Groundwater Application Review Summary Form

Application # G- 18768

PUBLIC INTEREST REVIEW FOR GROUNDWATER APPLICATIONS

TO: Water Rights Section Date 9/2/2020
 FROM: Groundwater Section Joe Kemper
 Reviewer's Name
 SUBJECT: Application G- 18768 Supersedes review of 8/20/2019
 Date of Review(s)

Figure 3. Water-Level Trends in Nearby Wells

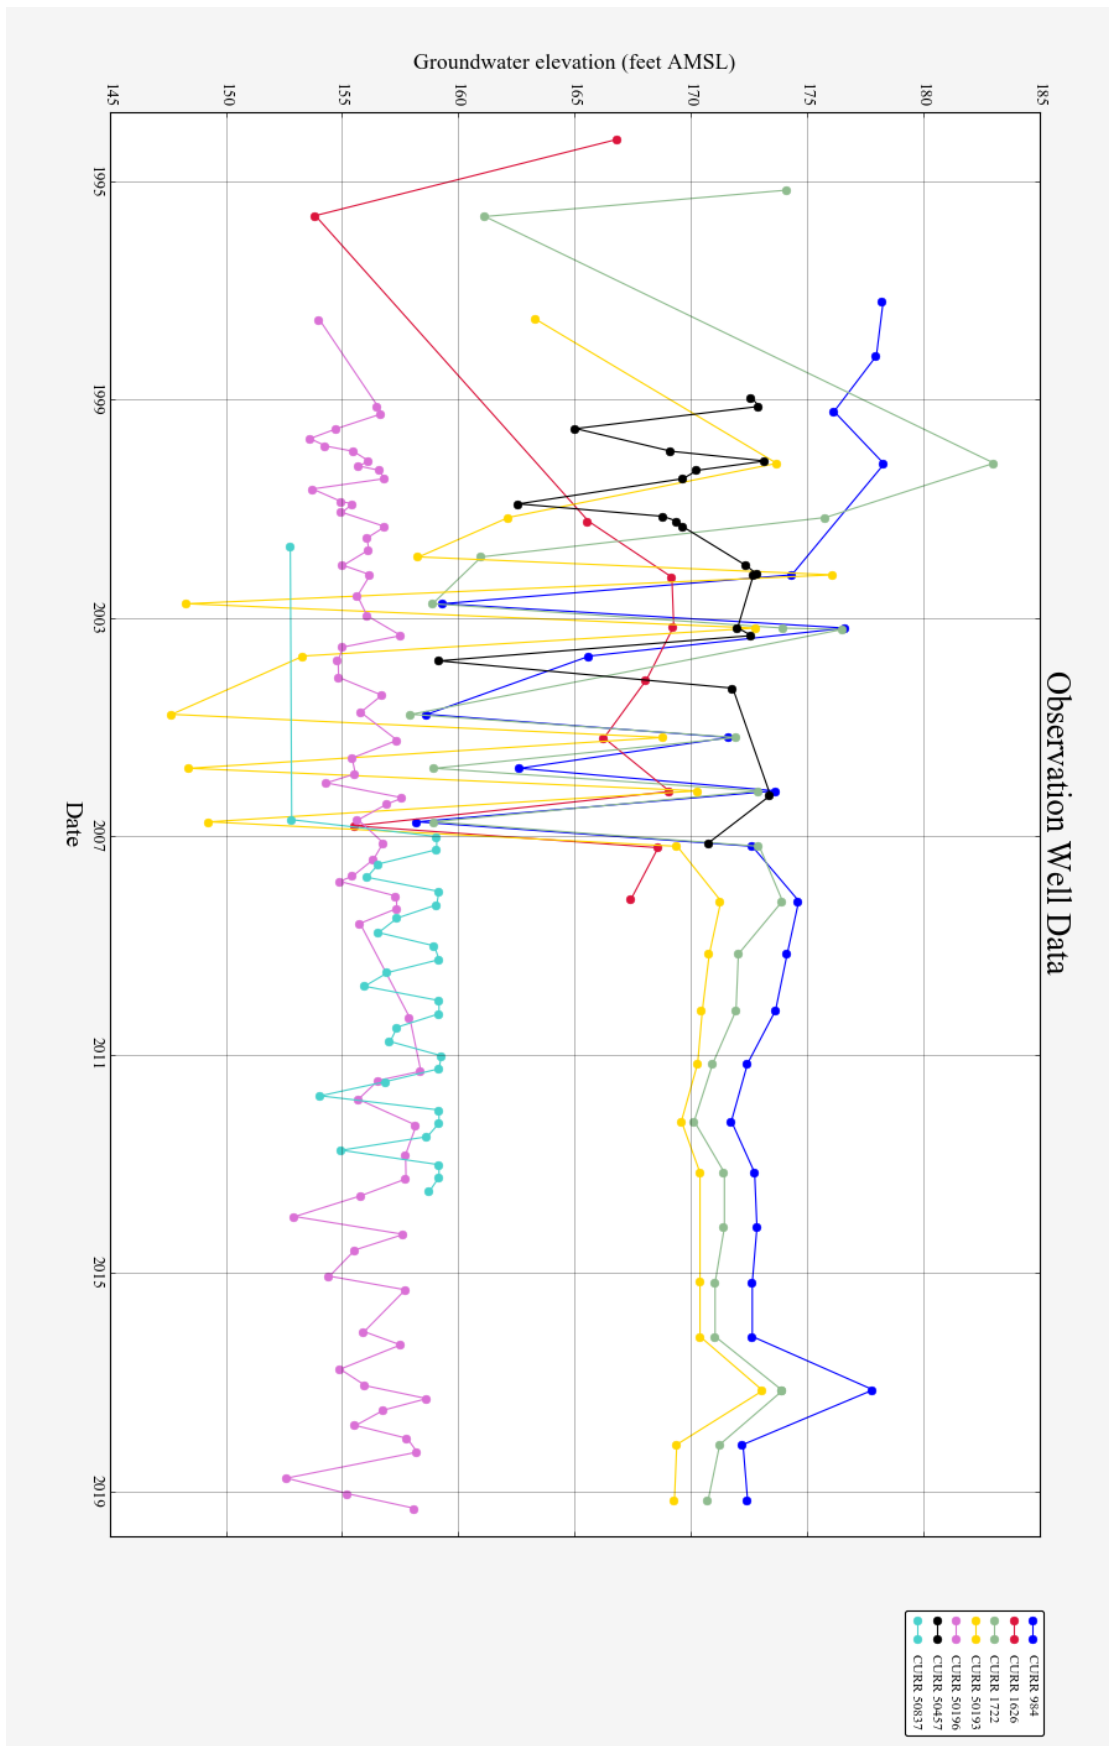
B3. **Groundwater availability remarks:** The applicant’s well will access an aquifer system hosted in the unconsolidated sediments of the Pleistocene-aged Pioneer terrace. Water levels in wells are typically shallow (typically 5-20 feet BLS) with seasonal fluctuations of 5-25 feet. Water level records in adjacent wells show no clear evidence for systemic declines (see Figure 3). There are several valid POAs within 500-1000 feet of the applicant’s wells, but the potential for significant interference is relatively low in this unconfined, moderately transmissive aquifer system. Additionally, the Department is not currently aware of interference/injury complaints in this area.

Figure 4. Stream Depletion Model Parameters and Results (Hunt, 1999)

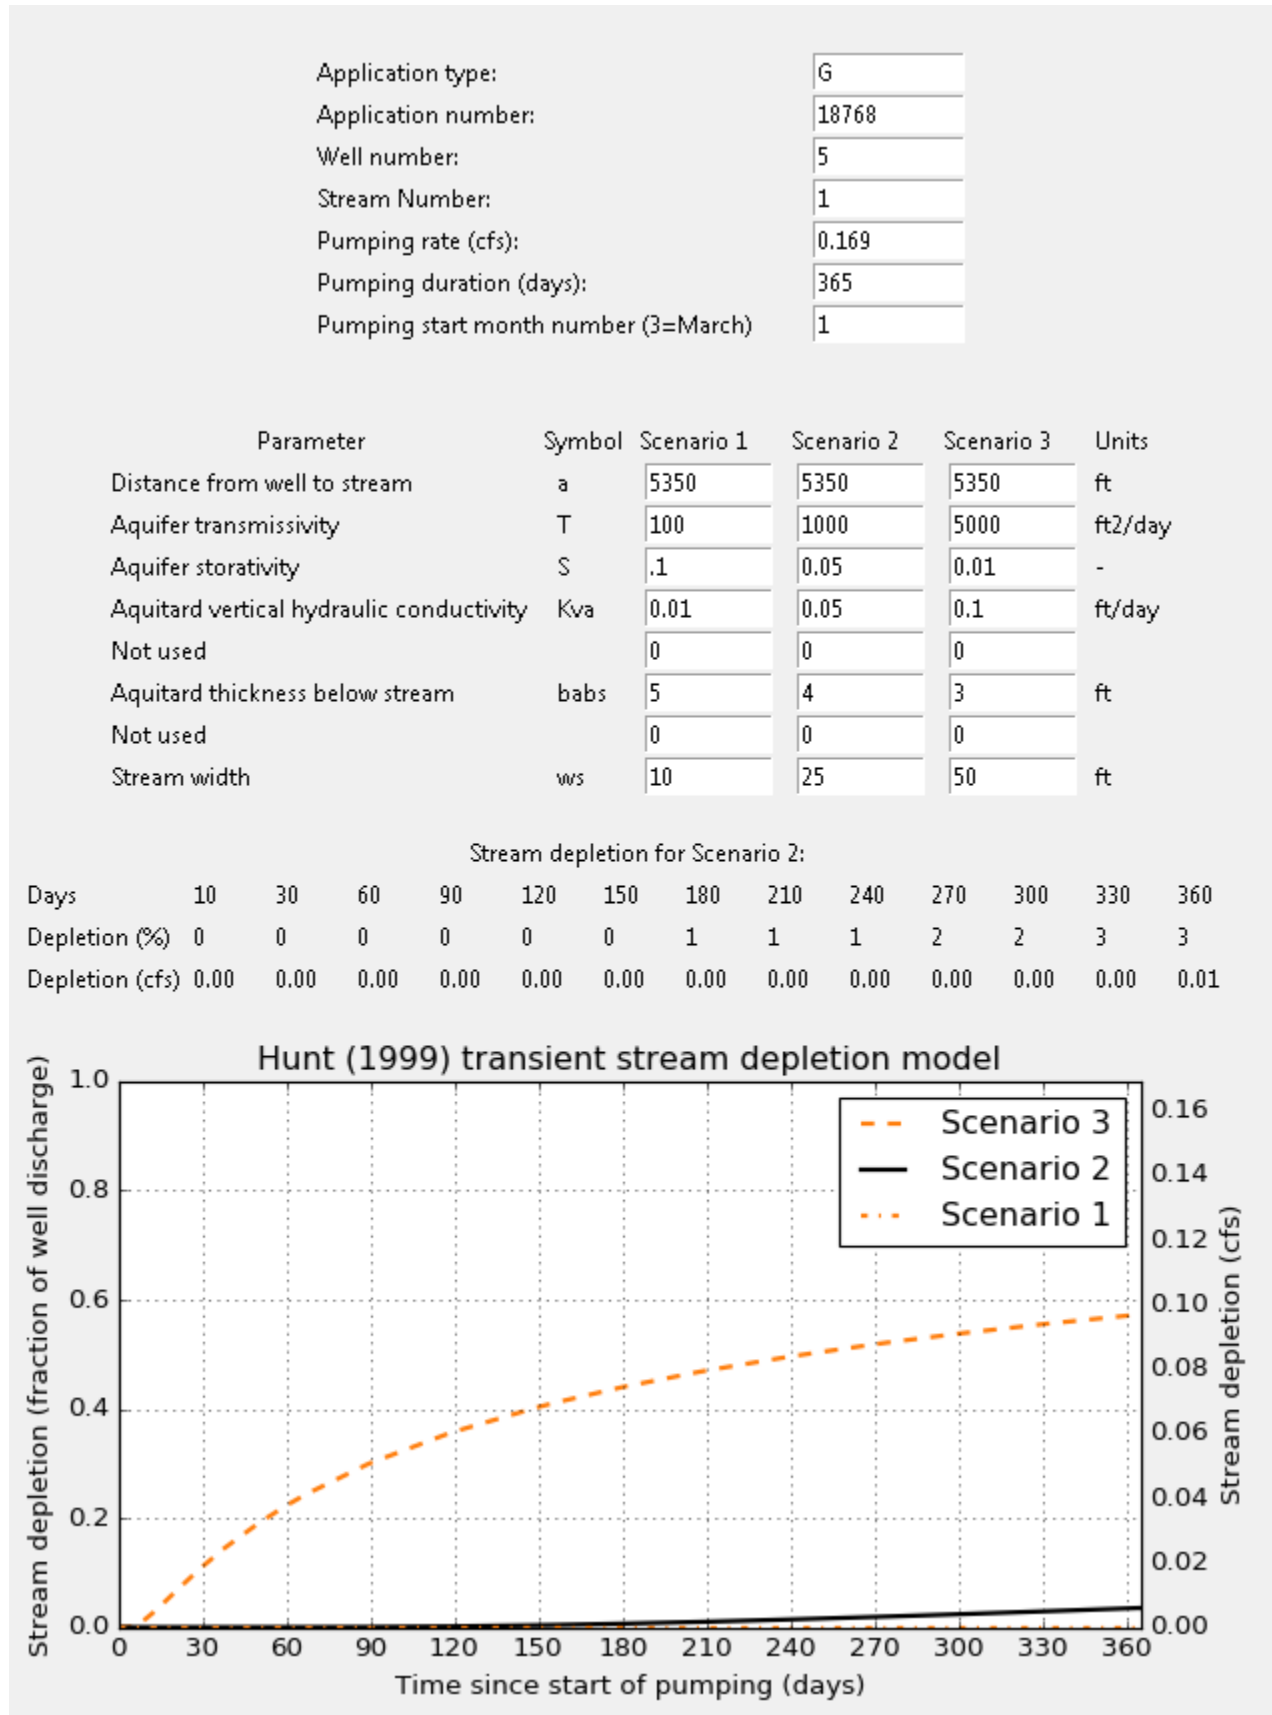
Comments: Interference with surface water is estimated using the Hunt (1999) stream depletion model using a parameter range representative of the local geology.

Basis for impact evaluation: Interference with surface water sources beyond one mile is estimated using the Hunt (1999) stream depletion model using a parameter range representative of the local geology. The results of stream depletion modeling in row (A) are greater than row (C) for multiple months, but these numbers are smaller than reasonable methods/certainty of measurement or calculation, and thus are not considered rigorous evidence for the assumption of PSI.
